Responses to s92 requests prepared by WSP in respect of landscape matters

OceanaGold MP4: S92 RFI – Landscape Matters

3-C1680.10

Please find below our response to the S92 RFI Questions 6 and 7 on landscape matters from the Dunedin City Council and the Waitaki District Council regarding the Macraes Phase 4 resource consent applications.

Figure 1: Topographical map showing ONL 11: Taieri Ridge (overlay in purple) as provided by WDC Plan Review Team (22.08.2024)

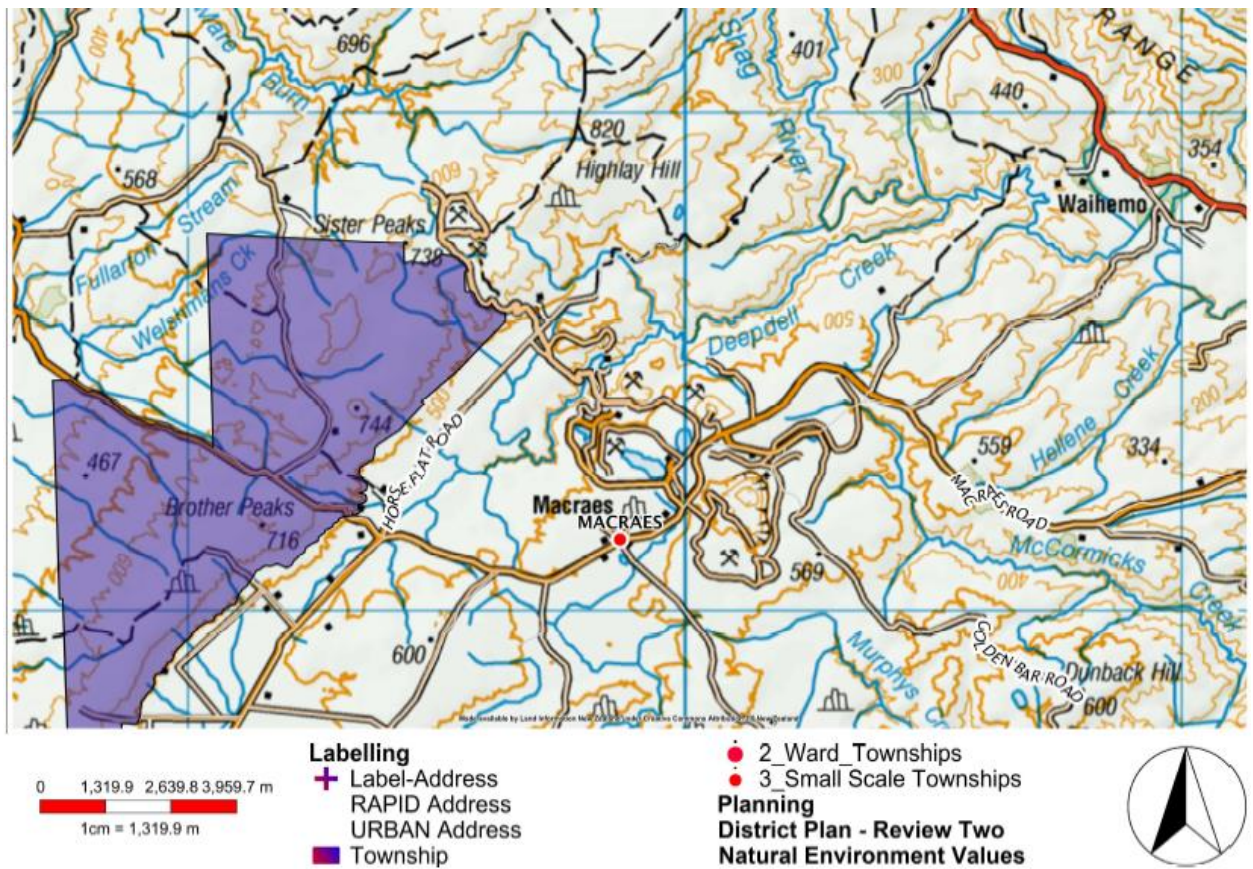
In the landscape assessment at 4.2 there is a heading referring to the Waitaki Landscape Study in which it is stated the *'those aspects of the Waitaki Landscape Study that relate to the Macraes Operation are described at Section 3.4.2.1 of this assessment'*.

However, Section 3.4.3.1 doesn't exist. There is also no mention of whether there are any Outstanding Natural Landscapes or Features that came out of the Landscape Study, included or affected by the proposed extension though the AEE documents states that there are no ONLs or ONFs affected.

The 'Section 3.4.2.1' reference appears to be an error. Regarding the findings of the WDC Waitaki Landscape Study, this is fully discussed at Section 4.5 Resource Management Act of the MP4 LVA. It notes that there are no ONLs or ONFs in the area.

However, the draft Waitaki District Plan now provides an updated list of ONLs that includes ONL 11- Taieri Ridge. This draft Plan has no statutory weight until it is notified. Its description notes that this ONL:

The Coronation component of MP4 does not propose any changes within the eastern (Mine South) face of the Taieri Ridge that falls within the Waitaki District, however the proposed Taieri Ridge ONL11 has the Coronation Haul Road as its topographical northern boundary.

Refer Figure 1 below. The proposed MP4 works are approximately a kilometre from the edge of the proposed ONL. If this ONL were to be included in an operative DP, there is a separation in terms of elevation and distance that the effect would be “very low” (equivalent to less than minor / negligible).

Figure 2: Snip from ZTV with yellow dashed line showing location of road.

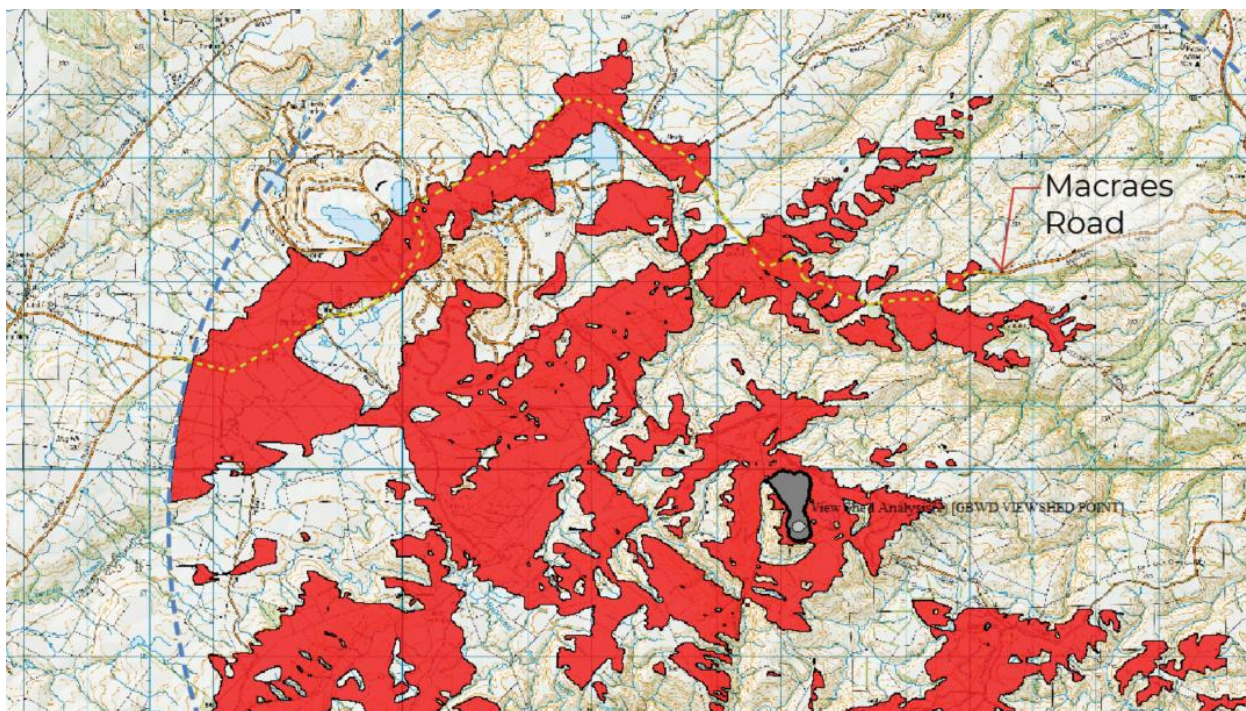
The Zones of Theoretical Visibility Mapping (ZTV mapping) method used are described including the limitations of the methodology and of the visual simulations. It is stated that several of the same viewpoints that were previously used for MP3 are used for MP4. The viewpoints and visual simulations while useful appear minimal for the scale of the extension sought.

Please comment as to why there are not more simulations especially of distant views. The Longsdale Road Stockyards visual simulation is the only distant view provided. The Zones of

Theoretical Visibility Map shows there are many locations where the rock stacks will be visible from distant views.

3. **Golden Bar:** According to the Zone of Theoretical Visibility (ZTV) (Refer attachment 3 of the LVA; a small snip of which is Figure 2 below) there is the possibility of distant views from Macraes Road (road highlighted in Figure 2). However, the following is noted of those viewing opportunities:

- Viewing the distant countryside while driving along Macraes Road would be hazardous. Noticing a contrast in the distant terrain and identifying it as a mine would be unlikely.

- While the ZTV does indicate visibility, it does not take into account the effect of distance between road and mine area (at least 4- 6km), the relative dimensions of the mine at this distance, or localised undulations in the road or the topography immediately adjoining the road (that would either obscure an outward view or make for short, interrupted views at best).

- Macraes Road is not orientated towards the site, placing Golden Bar in the distant peripheral view for the travelling public going towards Dunback. Travelling towards Macraes, the site would not be visible at all.

- Available to only a small viewing audience - there are very few if any safe stopping areas through the relevant section of Macraes Road, so it is unlikely the public will be stopping to view, especially now there is an advertised viewing area of the mine above Frasers Pit. In addition, Macraes Road is a low-volume rural road, which implies a low potential viewing audience. Golden Bar Road is rarely used, except by mine personnel and local farmers.

- Golden Bar will be increasingly less discernible as vegetation establishes. While the distant view to Golden Bar would present more of a contrast during the works, this will diminish once the grass cover of the Golden Bar waste rock stack has established.

- The viewing opportunities are, as mentioned, distant.
